The Bath & Wells Diocesan Association of Change Ringers

Kingston Seymour, All Saints, Initial Tower Inspection

All Saints, Kingston Seymour, North Somerset

4. Intermediate Chamber

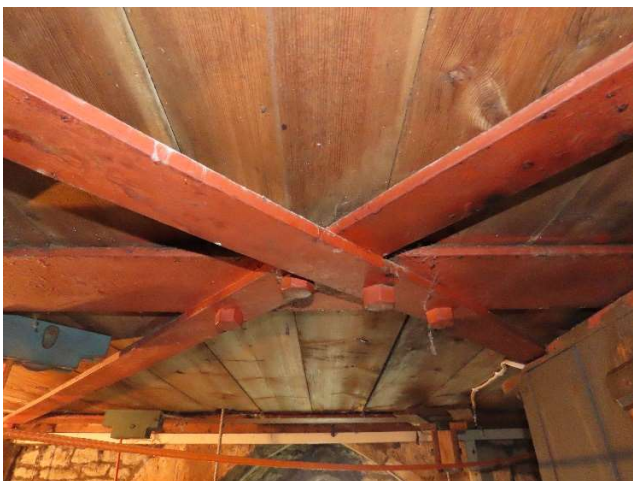
The ropes of the treble and second bells are drawn sideways slightly to form the rope circle below. This possibly contributes to the challenging handling of these two bells. The ropes for the remaining bells fall straight, including the 5th rope that falls through the clock case.

Ground pulleys are fitted to the treble, second and fourth bells. There is also a ceiling pulley on the treble and 4th bells. All pulleys rotated freely and were fitted with modern plastic style rollers that appeared in good condition. The rope on the 2nd bell did not quite align properly with the centre of the pulley.

b) Headstocks

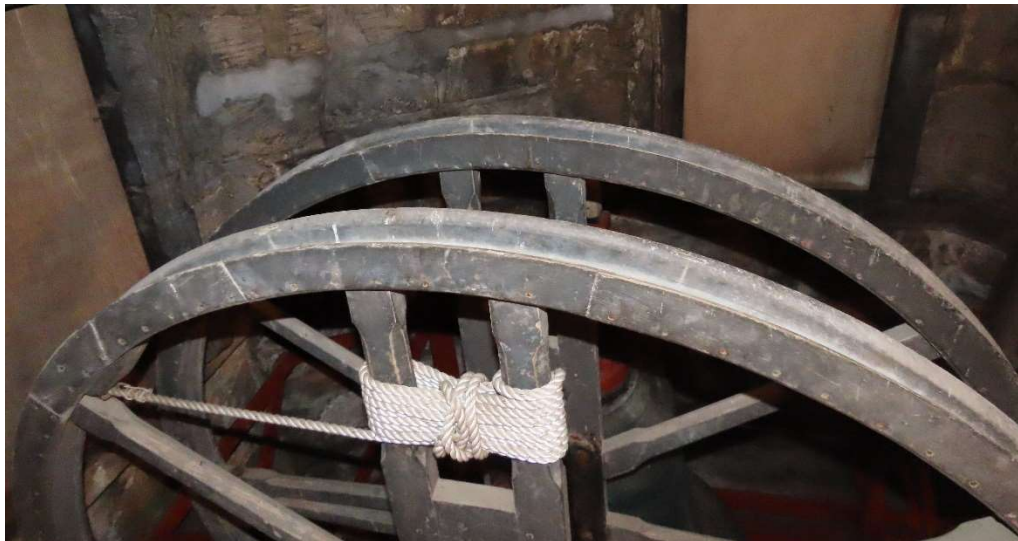
The bells are hung on cast iron headstocks supplied Llewellyns and James during the 1908 rehang. They are generally in good condition some minor spots of corrosion in a few places, particularly in the upper tier. Whilst not significant at this stage, repainting the headstocks in the next two to three years would prevent this becoming more significant.

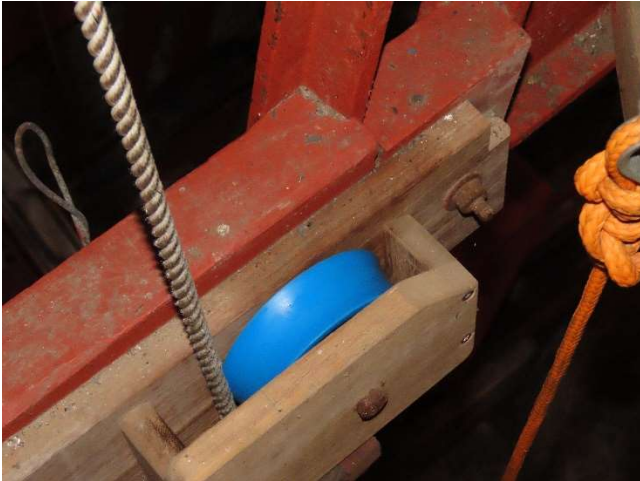
There are reports of occasional problems with the 5th slider where it occasionally jumps out of position particularly with rough handling. The hand stroke end stop of the 5th slider runner does show some damage which might be the cause of this problem. Replacement or repair of this runner should correct the problem. There is also significant wear at the slider rubbing surface and around the slider pin allowing it to rock slightly. Slider replacement would help resolve this issue.
